Ageas Bowl, Hampshire

Flood and Drainage Addendum 2

A Flood Risk Assessment (FRA) for the proposed development of the site at the Ageas Bowl (planning reference number F/22/93194) was provided by Andy Clay Consulting (ACC) in August 2022.

Figure 1 – Long Section of Culvert

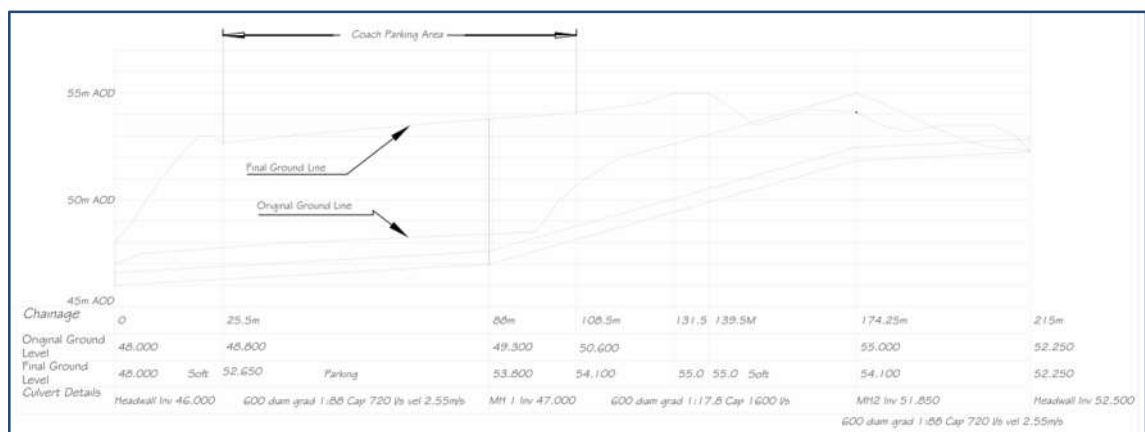
"The diverted watercourse (thick dashed line) should be de-culverted as much as possible."

As stated in the FRA and noted in the meeting, the proposed development would replace and re-align the culverted section of the watercourse in the western part of the site. The inclusion of a longer section of open channel was investigated, but unfortunately this was limited due to the depth of the culvert in the ground, the location of the inlet from Telegraph Wood and also the discharge at the outlet end.

With the amendment to the layout, we will of course look to see if the open section of watercourse (and therefore the amount of de-culverting) can be increased. Appendix C of the FRA provided a long-section of the culverted watercourse which further illustrates this – included below as **Figure 1**.

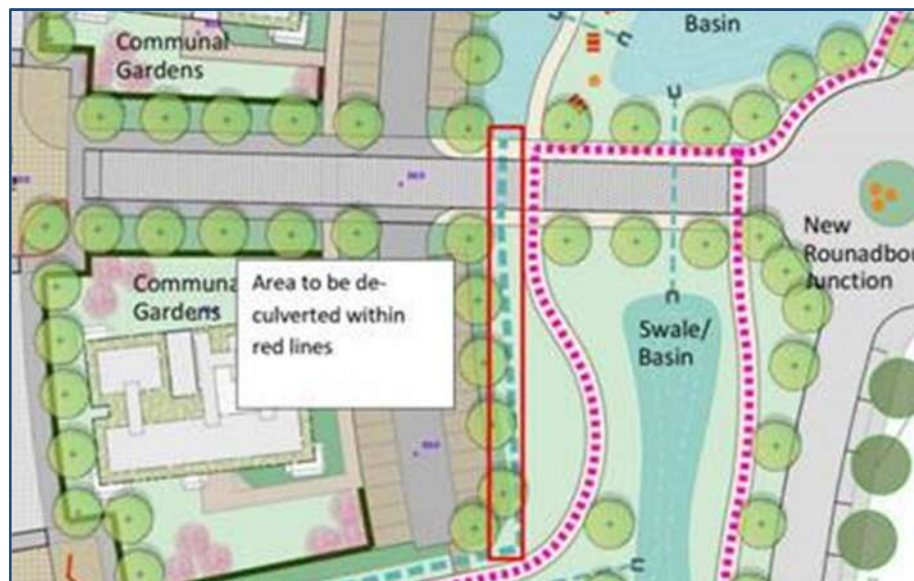
“The area labelled Attenuation Pond should not be an attenuation pond. It is the watercourse, because the culverted Telegraph Brook flows into it when it exits the culvert. It should be profiled as a watercourse, and should be managed as a watercourse, with a low flow, two stage channel and not a trapezoidal channel.”

Please find attached the drainage plans that were previously included in the FRA Addendum – but provided in a reduced file format as **Appendix A** including an indication of where surface water runoff is conveyed and also a compressed file format as **Appendix B**. This labels the various part of the drainage strategy, and does not show the watercourse as an attenuation pond (but as a watercourse).

As advised in the FRA and also noted in the meeting, it is the aim to include the watercourse as a two-stage channel. However, the flood model would need to ensure that this channel profile can be achieved in all locations without resulting in an adverse flood risk.

Figure 2 – SuDS Manual Extract on Gravel Filled Filter Drains

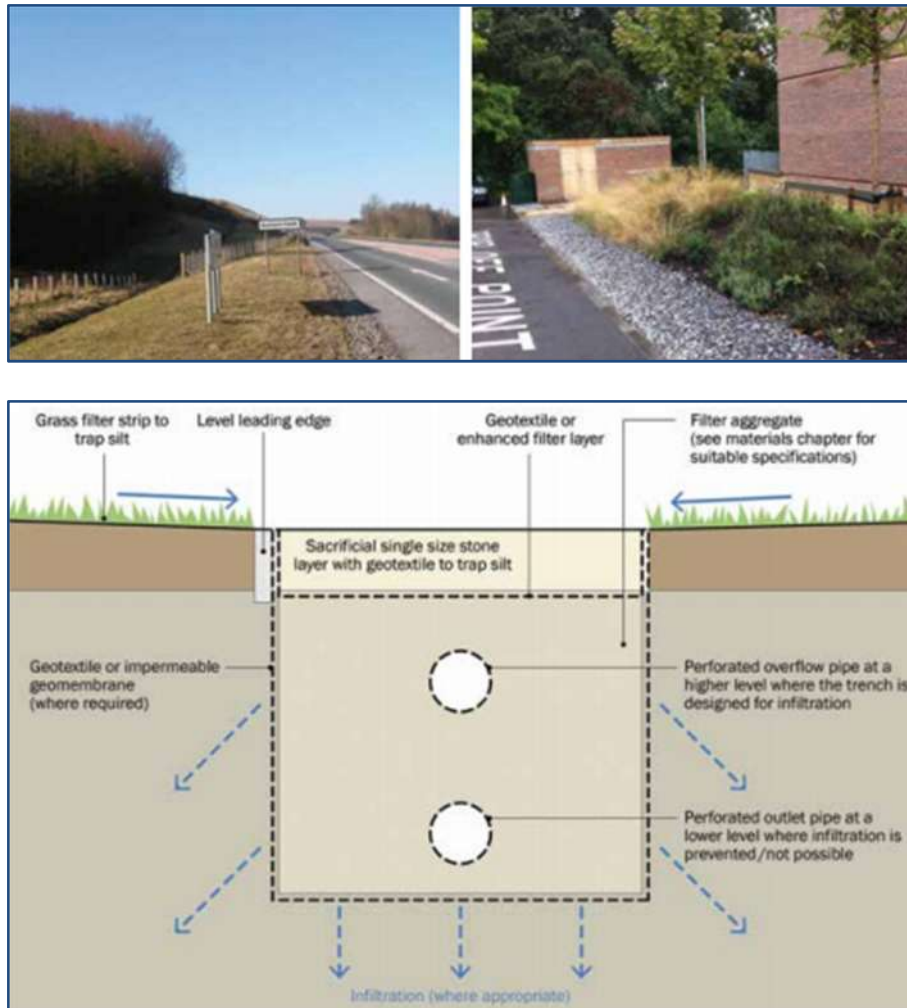
“Most of area 5 is proposed to be drained by permeable paving, the swale/basin and the basin before discharge into the watercourse. This would provide 3 forms of filtration, of which 2 are naturalised. The

lakes within the golf course must provide another form of naturalised filtration for this water, the final level of treatment before it is discharged off site"

However, this still leaves Character Area 1a with one form of treatment. The options available are to include a gravel filled filter drain along the edge of the parking area, parallel to the drainage channel. Surface water would naturally drain through this filter drain prior to draining into Biodiverse Channel B.

The SuDS Manual provides advice on gravel filled filter drains, and that they can be designed to provide attractive boundary lines or edging and can be protected with a geotextile or even covered with topsoil and planted with grass. An extract from the SuDS Manual is included below as **Figure 2**.

Given the temporary nature of the car parking across the site, we consider that there is the potential to park on the gravel filled filter drain so long as the surface is protected with an appropriate geotextile.

Figure 3 – Flood Modelled Catchment Extent

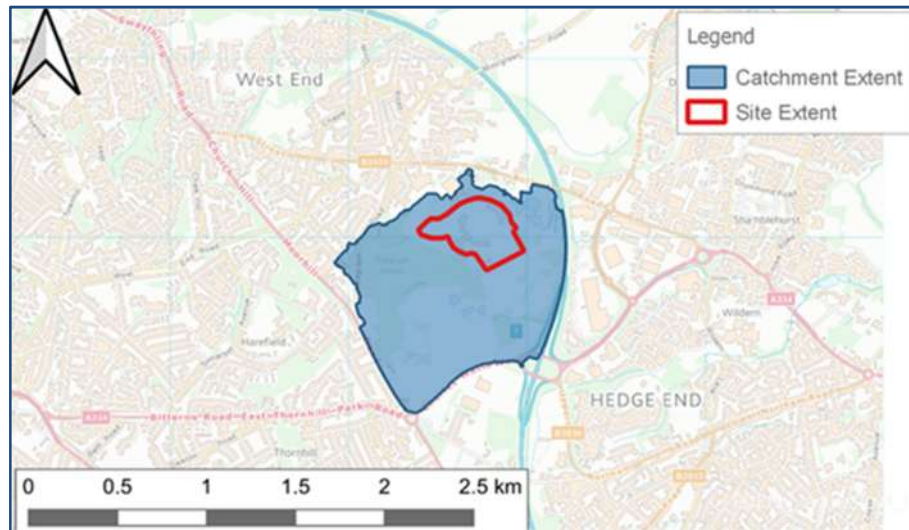
The LPA and LLFA also asked about the extent of the hydrological catchment that drains to Telegraph Brook. The extract included below as **Figure 3** is from the flood modelling, and shows that the hydrological assessment resulted in the following catchment area for the flood modelled reach.

This shows the whole flood modelled extent (i.e. the hydrological catchment down to the two existing lakes). Whereas the hydrological catchment upstream of the culvert inlet from Telegraph Wood would be less than this, and is indicated by the extent of sub-catchment 1 as illustrated in **Figure 4**.

Figure 5 – Flood Modelled Sub-Catchment Extent

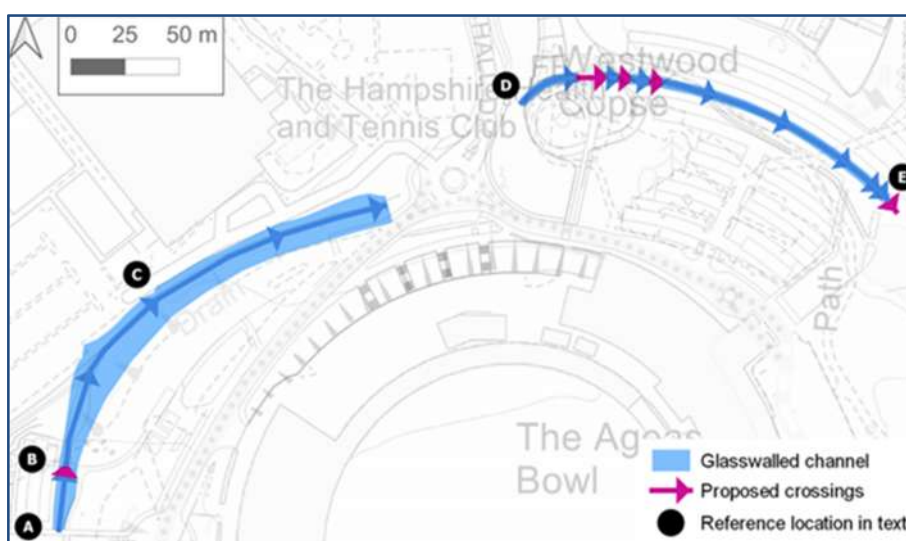
The LPA and LLFA also asked about the flows of water along Telegraph Brook.

The model node locations are indicated in **Figure 5**, with model node A located at the upstream end and model node E located at the downstream end.

This shows that at model node A there is very little change across events, with this largely a result of the existing culvert throttling the flows from sub-catchment 1. As would be expected, flows accumulate with distance downstream (model nodes D and E) due to the intake of flows from sub-catchments 2 and 6.

In summary, at model node E (upstream of the existing two lakes) then even with the 1 in 100-year event – the flows in the watercourse are $0.37 \text{ m}^3/\text{sec}$. This is not a significant flow for a flood event.

The assumptions that the flood modelling have made to date with the channel shape / geometry in the post-development modelled scenario are as follows (refer to **Figure 5** as above for location):

- Model nodes A to B – modelled as a two-stage trapezoidal channel (with a 0.2m deep low-flow channel);
- Model nodes B to C – modelled as trapezoidal channel;
- Model nodes C to D – the existing watercourse and culvert were modelled; and
- Model nodes D to E – modelled as a 3m wide rectangular channel (i.e. not two-stage).
